CROWN STREET WOLLONGONG

RTS DESIGN RESPONSE
WOLLONGONG DEVELOPMENTS NO.8 PTY LTD

RtS DESIGN RESPONSE PURPOSE

DPHI-12

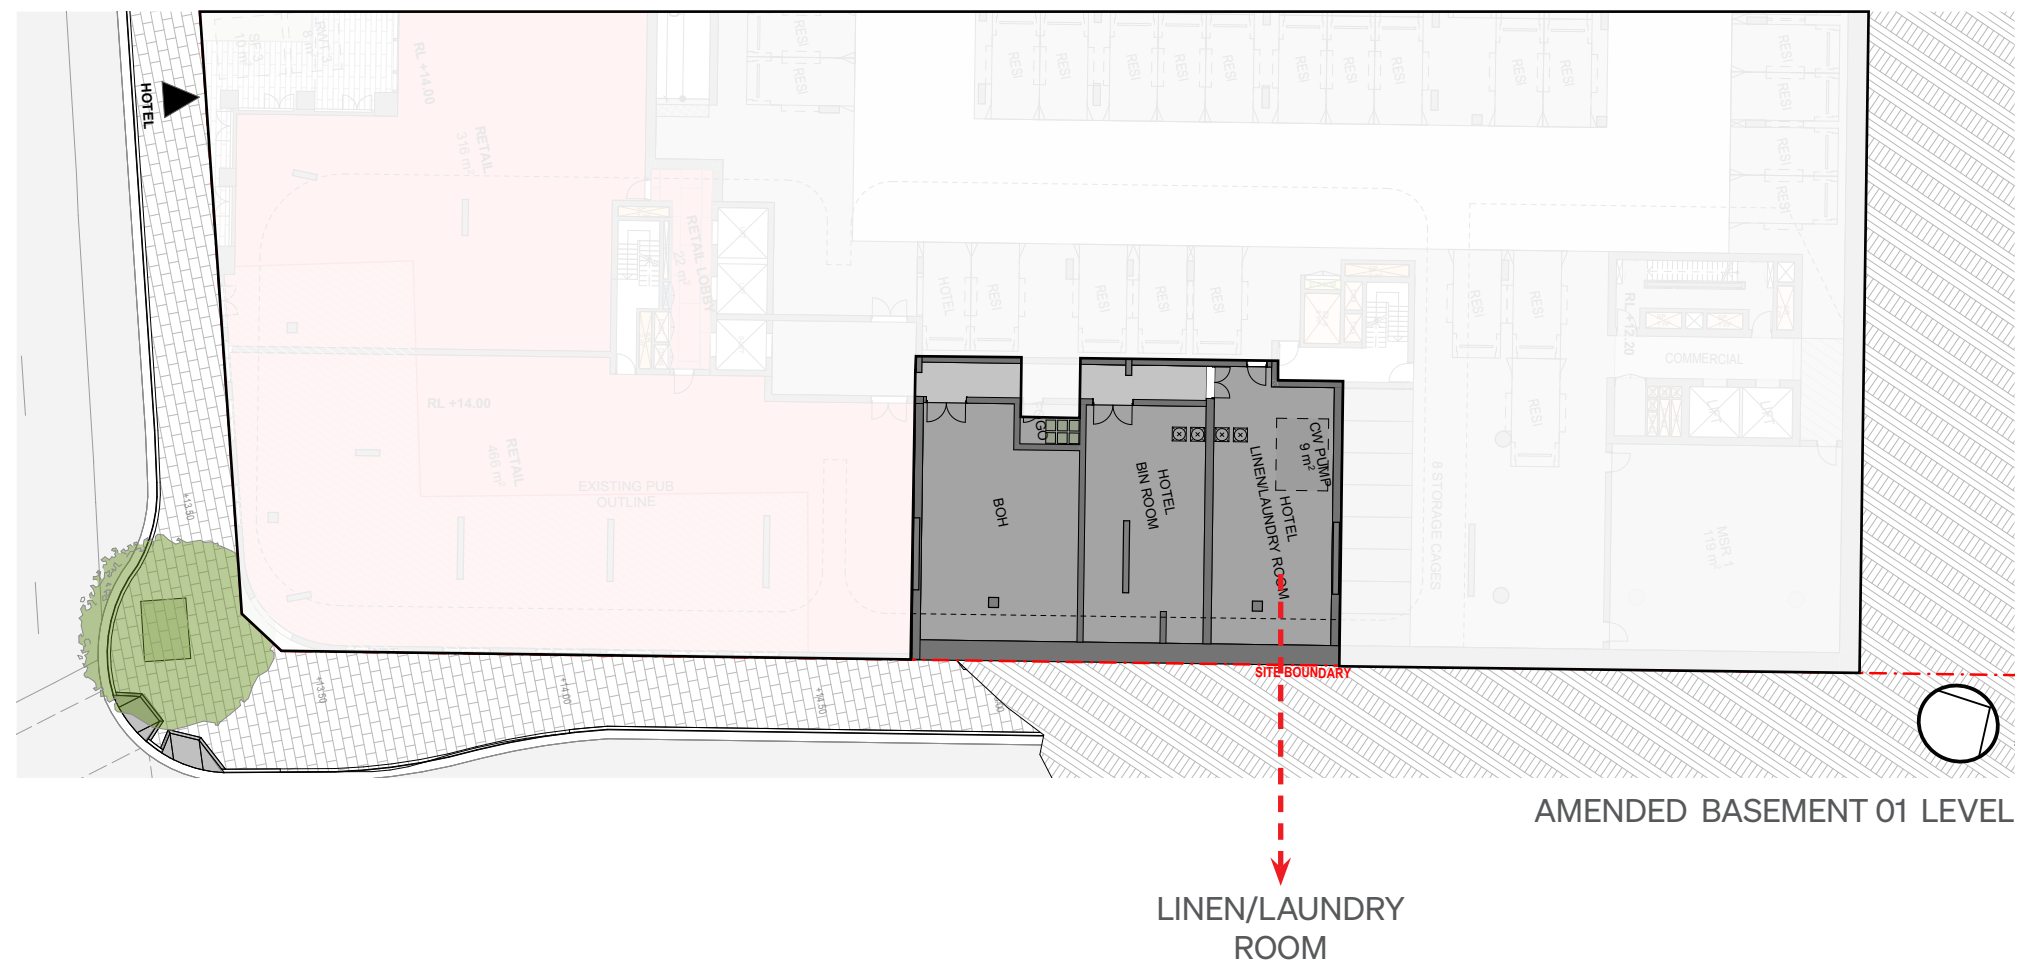
Clarify if the hotel will be provided with an on-site laundry service of sufficient capacity to service the development. If no laundry is provided, detail how the hotel will be serviced, update the plans and traffic and loading assessments accordingly. .

On site Laundry provided on the basement with Linen Chute. Refer to drawing DA2001.

BUILDING 2.1 CROWN STREET ENTRY

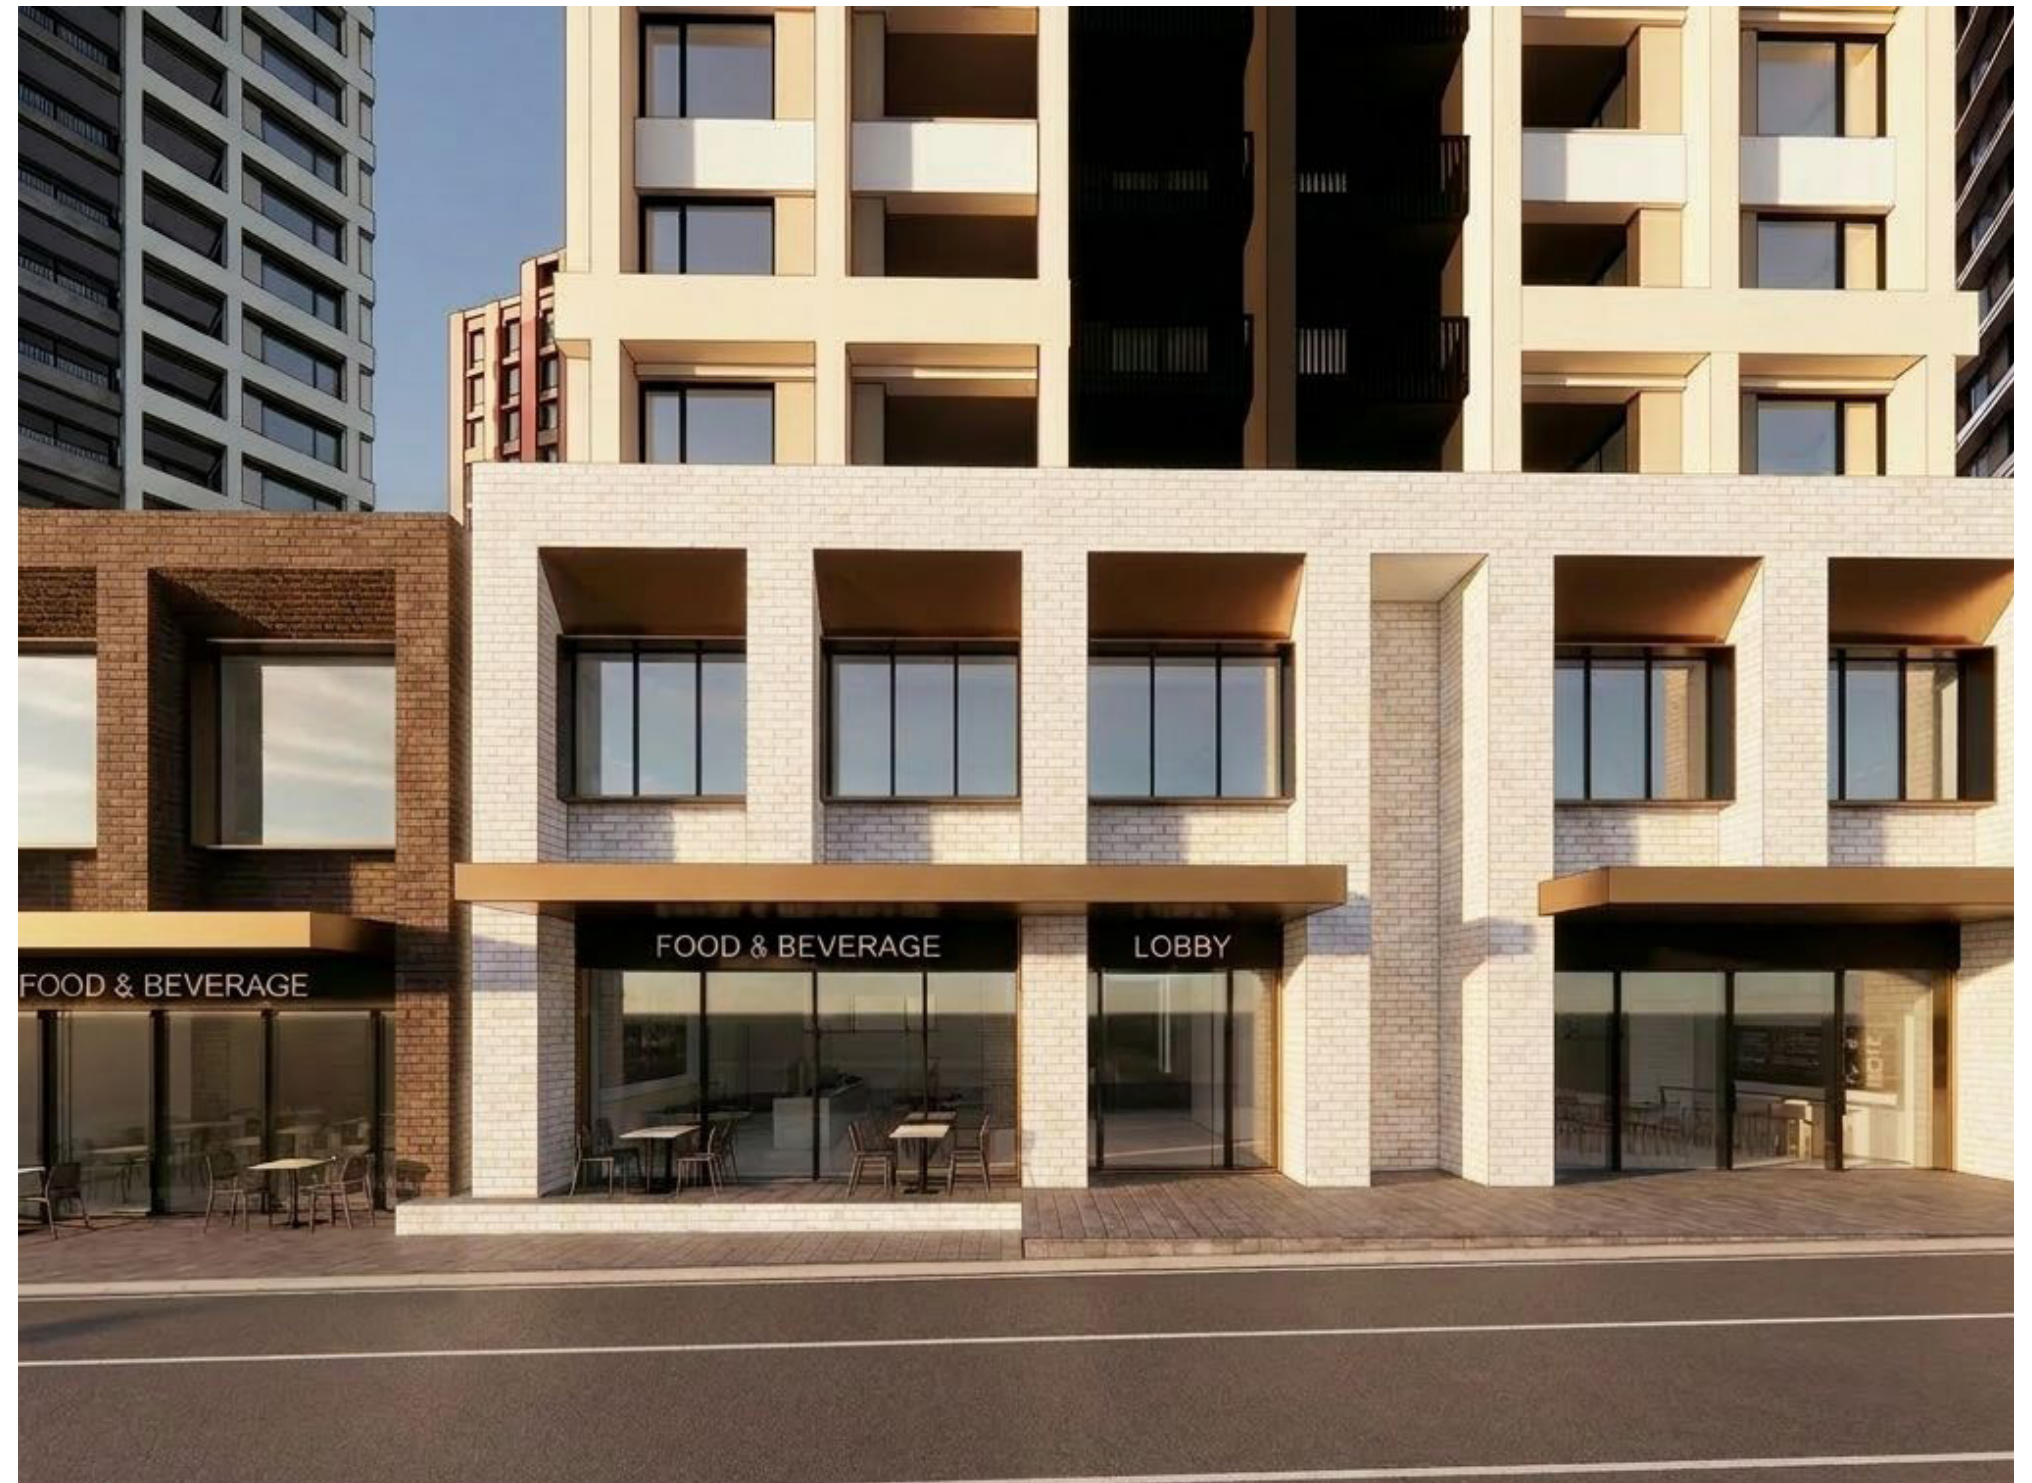
Provide detailed elevations and renders of entries into each residential lobby on the site.

Lobby entry renders added.

BUILDING 2.2 BURELLI STREET ENTRY

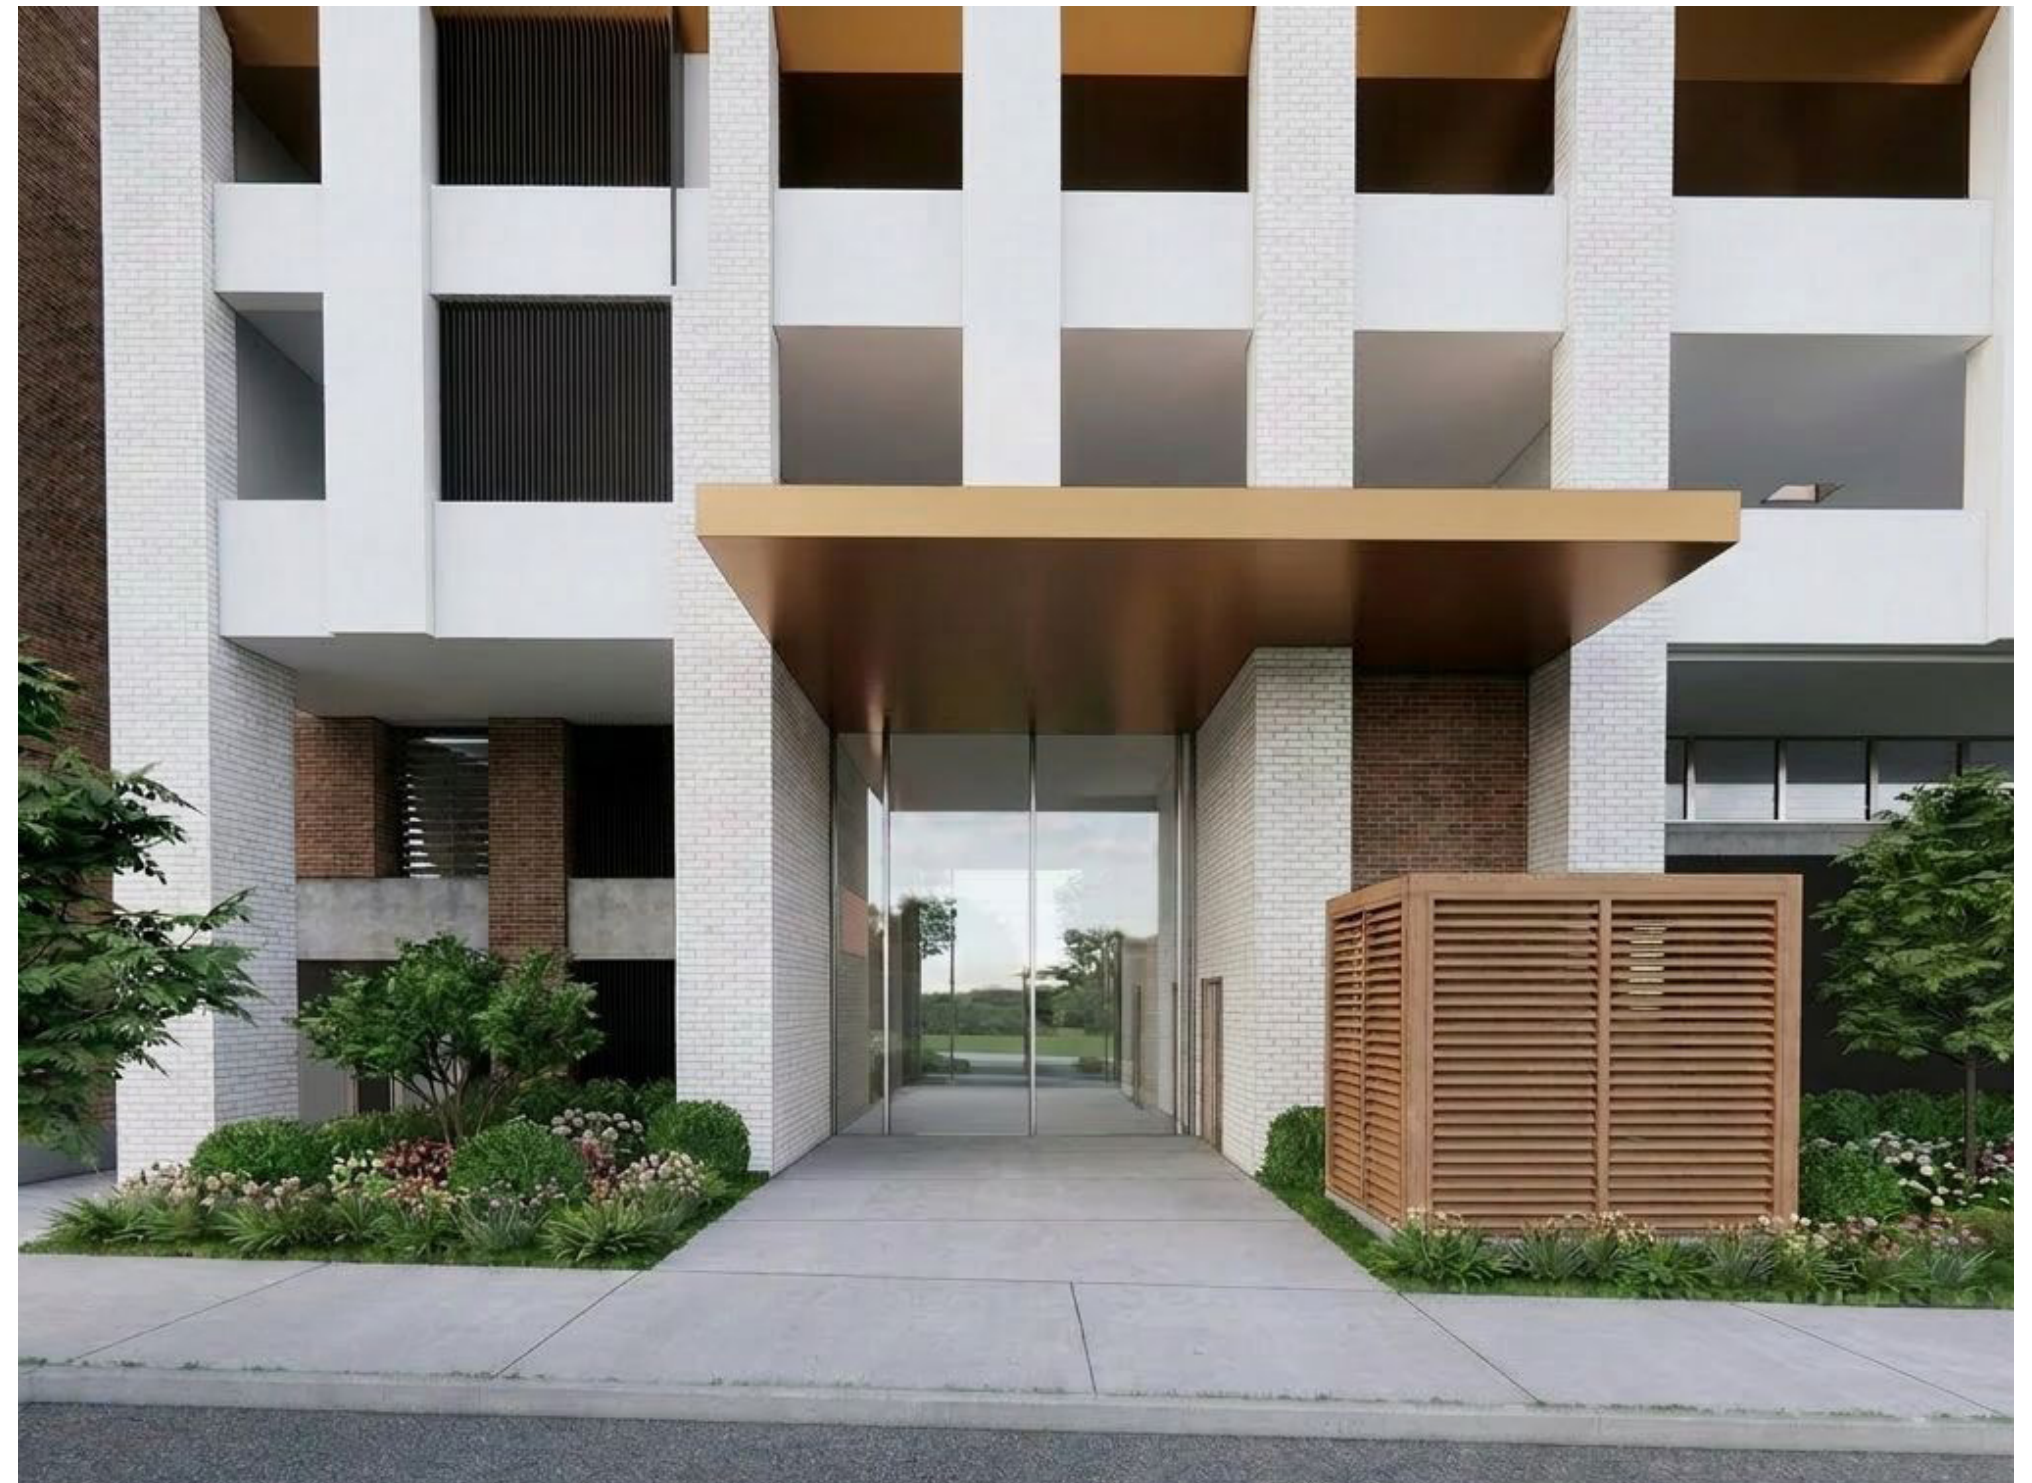
Provide detailed elevations and renders of entries into each residential lobby on the site.

Lobby entry renders added.

BUILDING 2.3 BURELLI STREET ENTRY

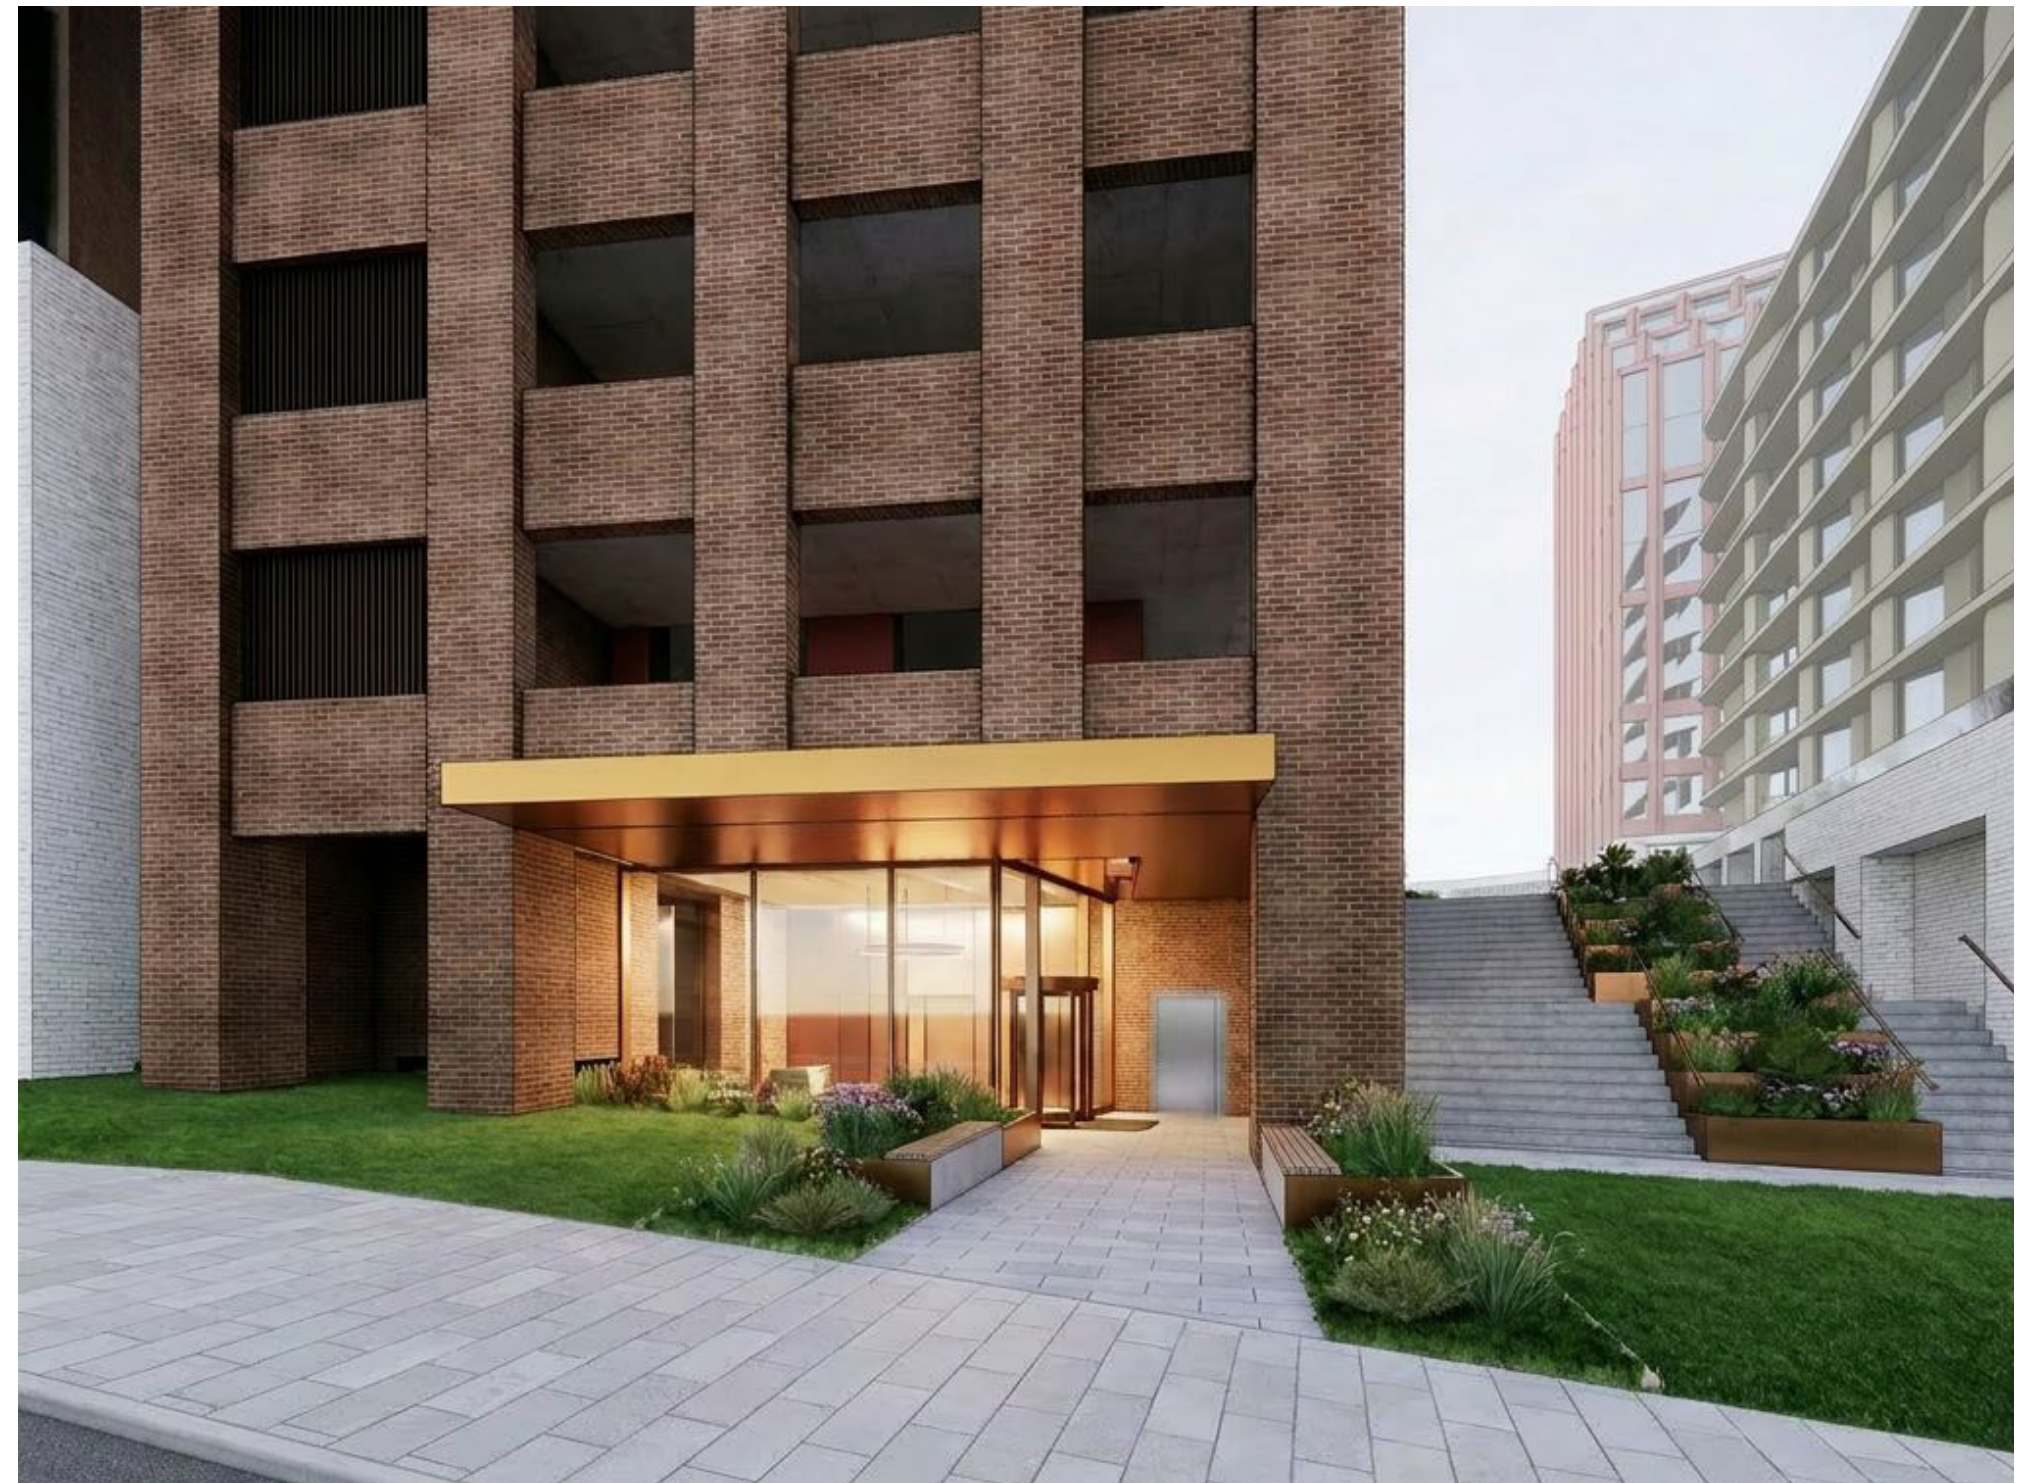
Provide detailed elevations and renders of entries into each residential lobby on the site.

Lobby entry renders added.
